**RAIL CROSSING #900-613N  
 DORSET - US ROUTE 7  
 RR MILE POST 27.94**

**RAILROAD CONCRETE PANEL REPLACEMENT**

PROJECT NAME:	MANCHESTER-RUTLAND TOWN
PROJECT NUMBER:	NH SURF(50)
FILE NAME:	p14v200frm.dgn
PROJECT LEADER:	M. FOWLER
DESIGNED BY:	B. KIPP
RAIL CROSSING DETAIL SHEET	
PLOT DATE:	1/14/2016
DRAWN BY:	B. KIPP
CHECKED BY:	N. PAPPAS
SHEET	95 OF 105

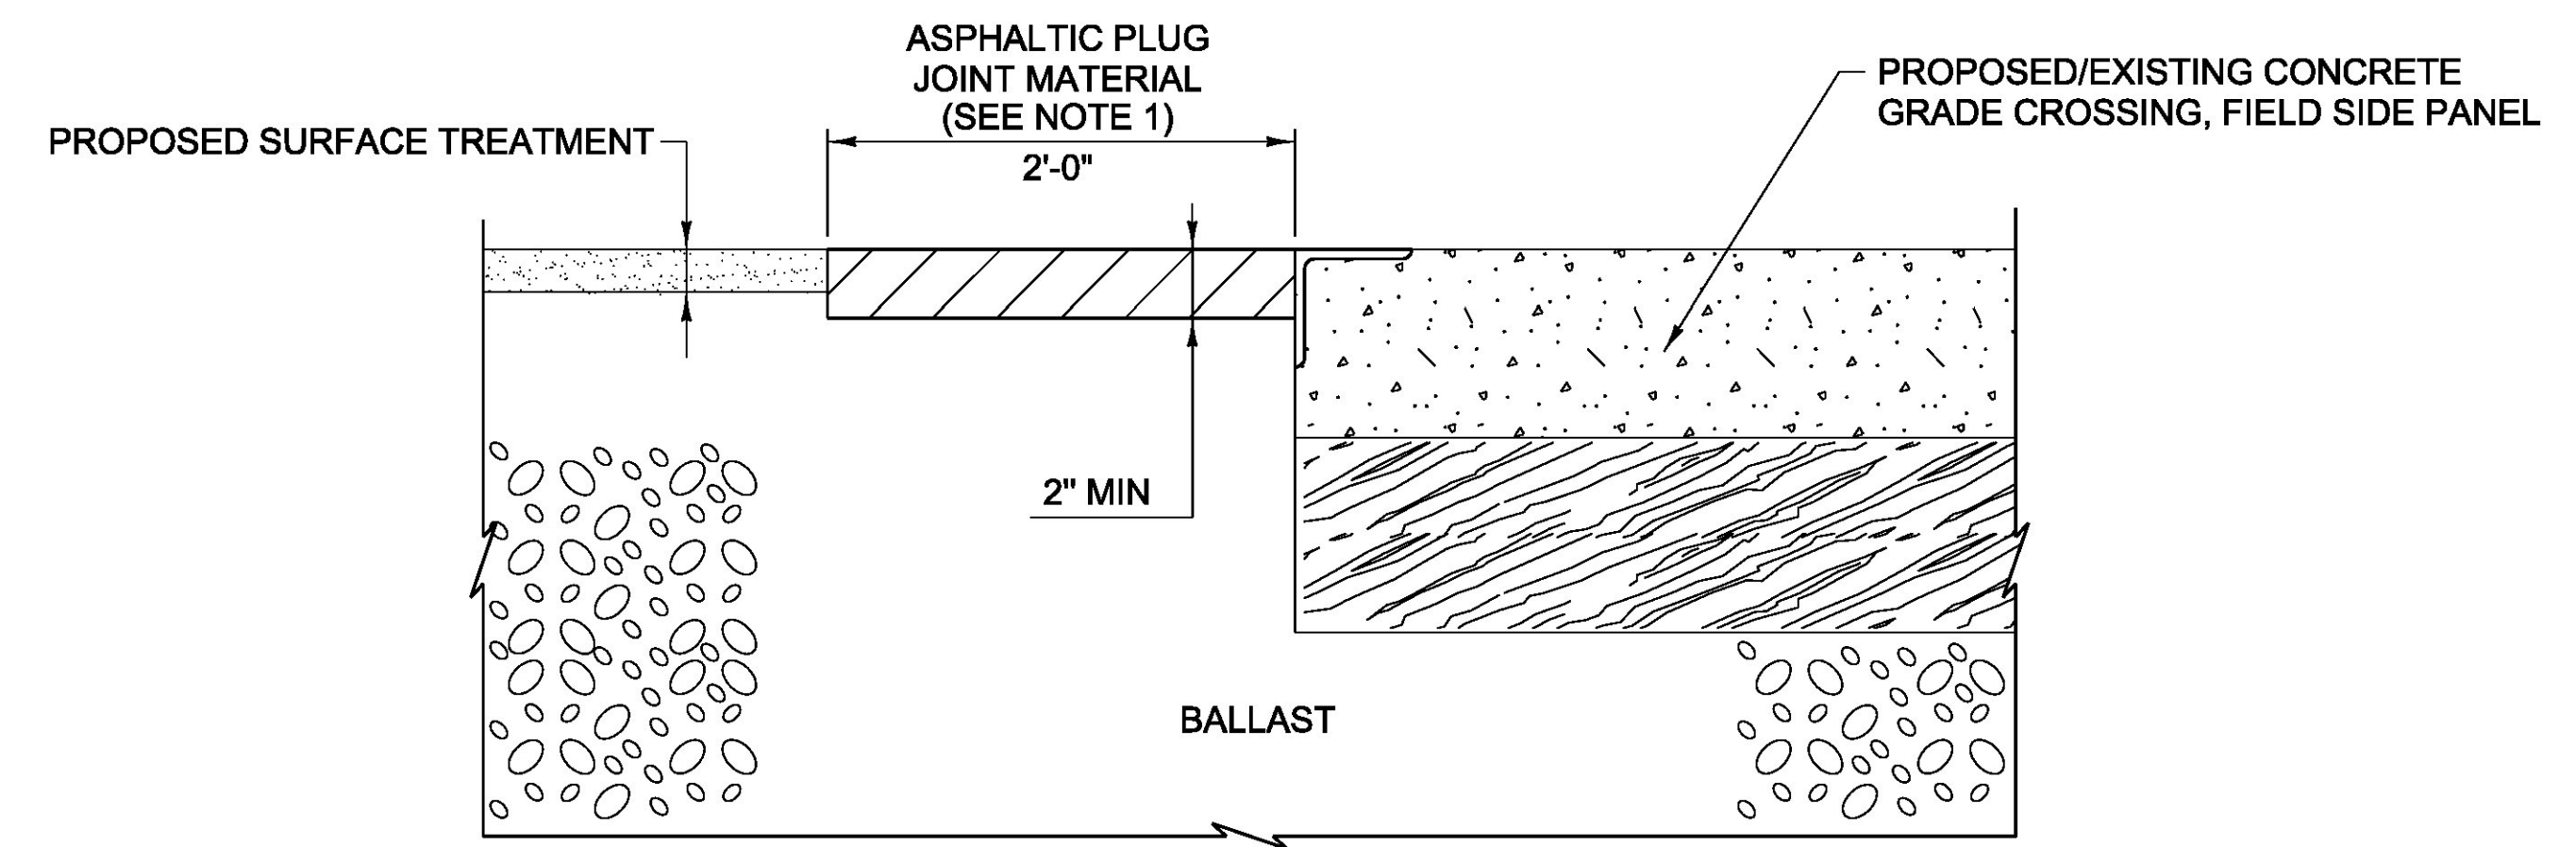
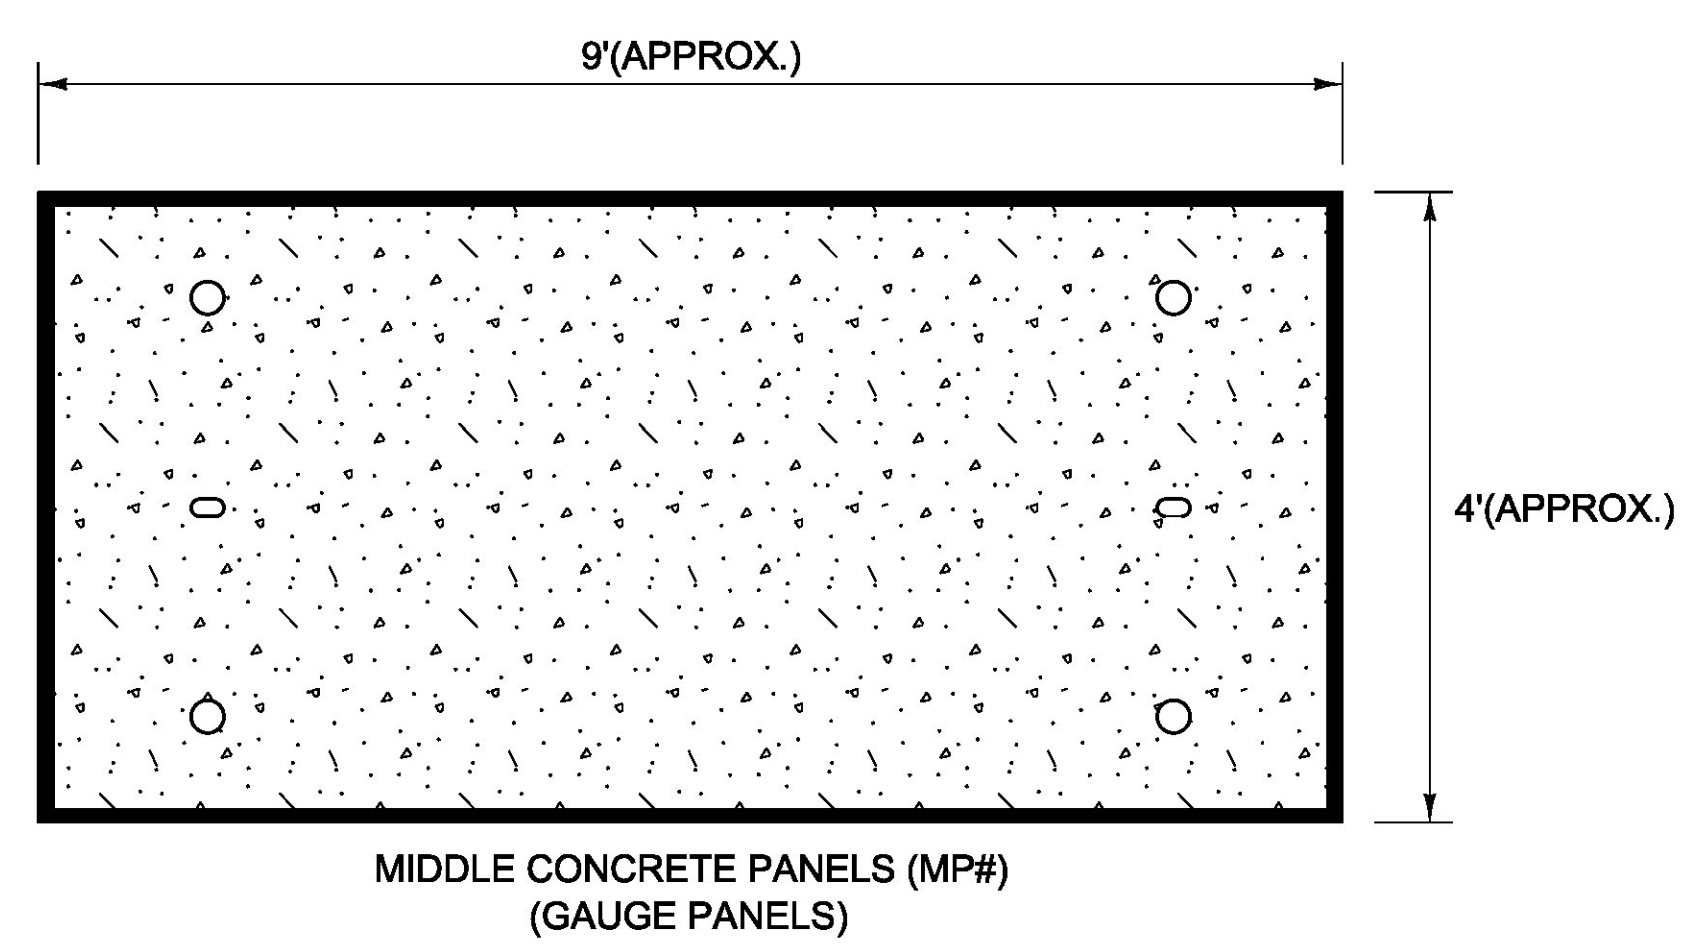
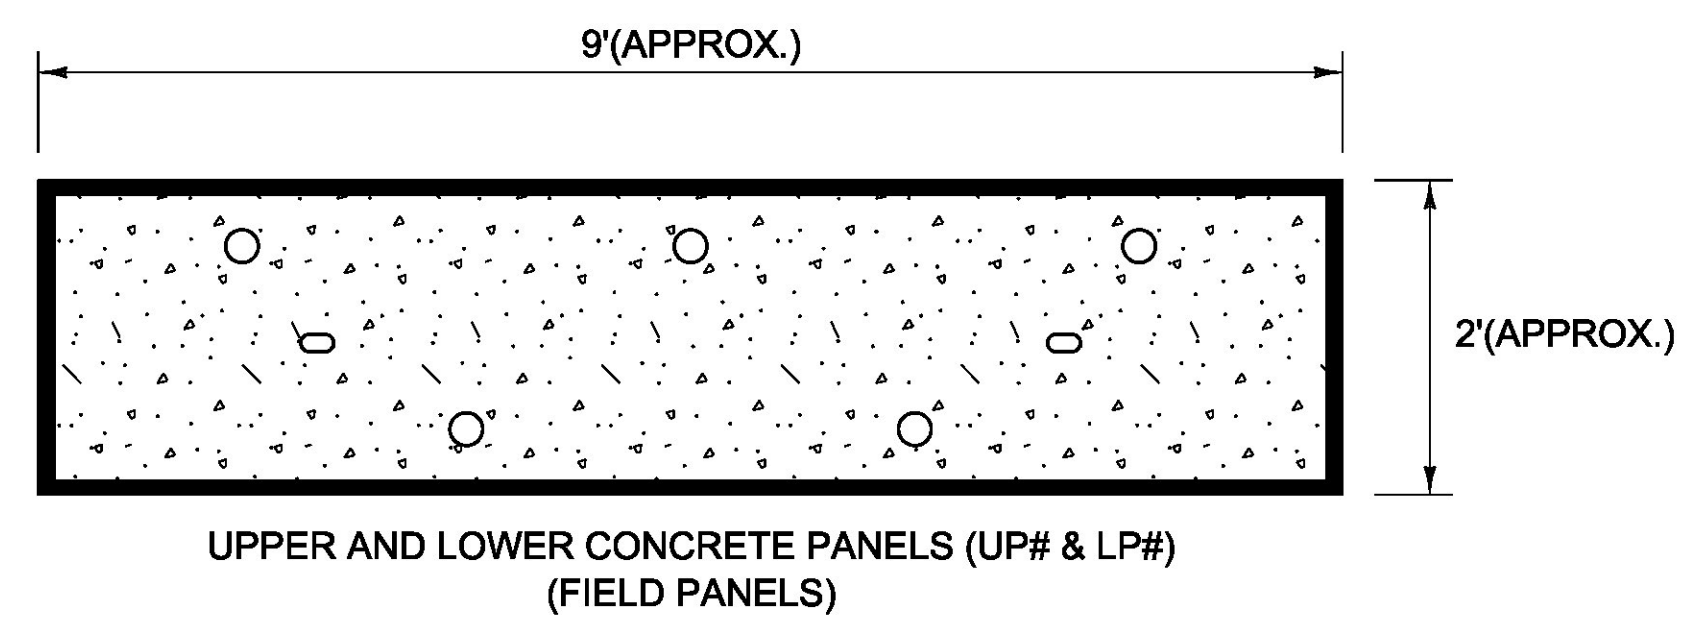
Actual Panel Replacements:  
 UP: 3, 4, 8, 11, 12, 16, 17, 19, 23, 25, 27, 28, 29, 30  
 MP: 2, 3, 4, 5, 10, 14, 16, 17, 22, 23, 25, 26, 28, 29, 30

UPPER PANEL REPLACEMENTS (UP#)	<del>UP3</del>	<del>UP4</del>	<del>UP12</del>	<del>UP17</del>	<del>UP23</del>	<del>UP27</del>	<del>UP28</del>	<del>UP29</del>	<del>UP30</del>
MIDDLE PANEL REPLACEMENT (MP#)	<del>MP14</del>	<del>MP16</del>	<del>MP22</del>	<del>MP23</del>	<del>MP25</del>	<del>MP26</del>	<del>MP28</del>	<del>MP29</del>	<del>MP30</del>
LOWER PANEL REPLACEMENTS (LP#)	<del>LP8</del>	<del>LP11</del>	<del>LP16</del>	<del>LP19</del>	<del>LP25</del>	LP: NONE	replaced
